Re: Quik Trip 7001 Unser and I-40 – Traffic Study Comments and Access

Re: Quik Trip Store # 7001
521 Unser Blvd. NW
Conceptual Traffic Circulation Layout for DFT Approval
Engineer's Stamp 05-31-24 (K10-D071)

SHEET NUMBER:
C100
05 OF 25

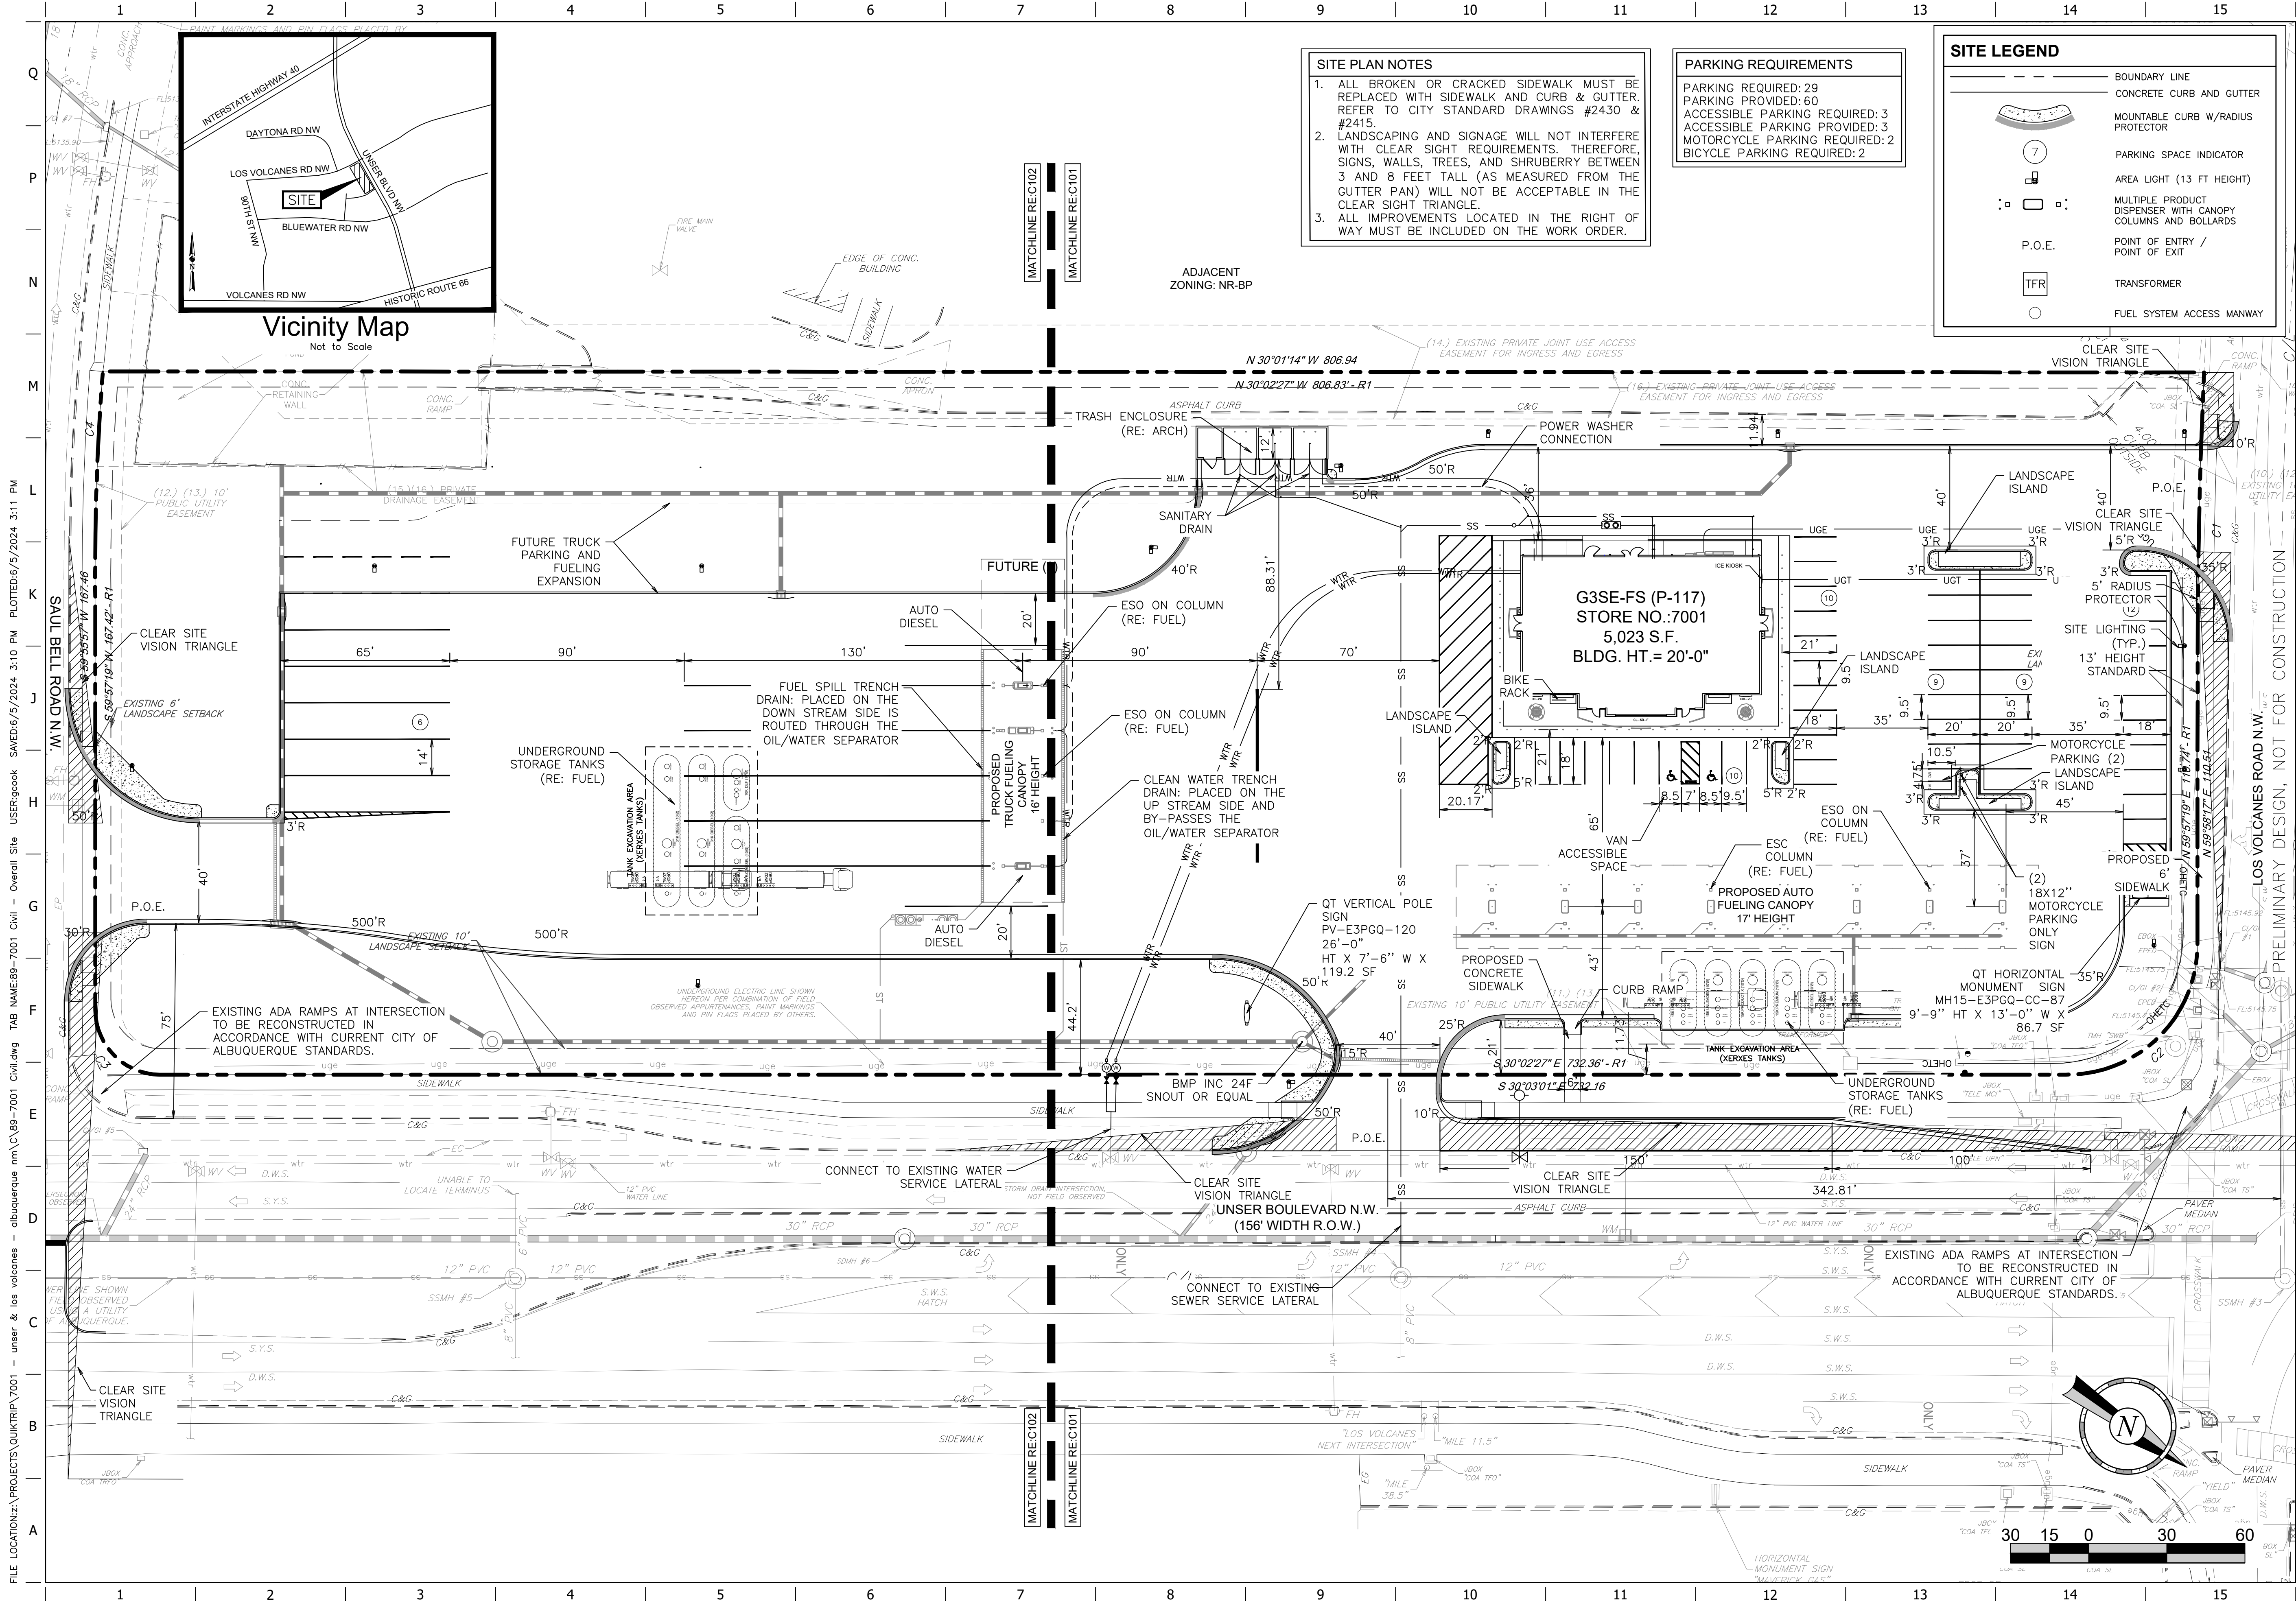
1. **An approved TIS must be provided.**
2. **Sheet C100: ADA parking aisle width should be minimum 8 ft.**
3. **Sheet details C510: ADA parking spaces width should be minimum 8.5 ft.**
4. **The minimum ADA pathway from the ADA parking aisle to the building entrance should be 6 ft. please show this dimension on the site plan.**
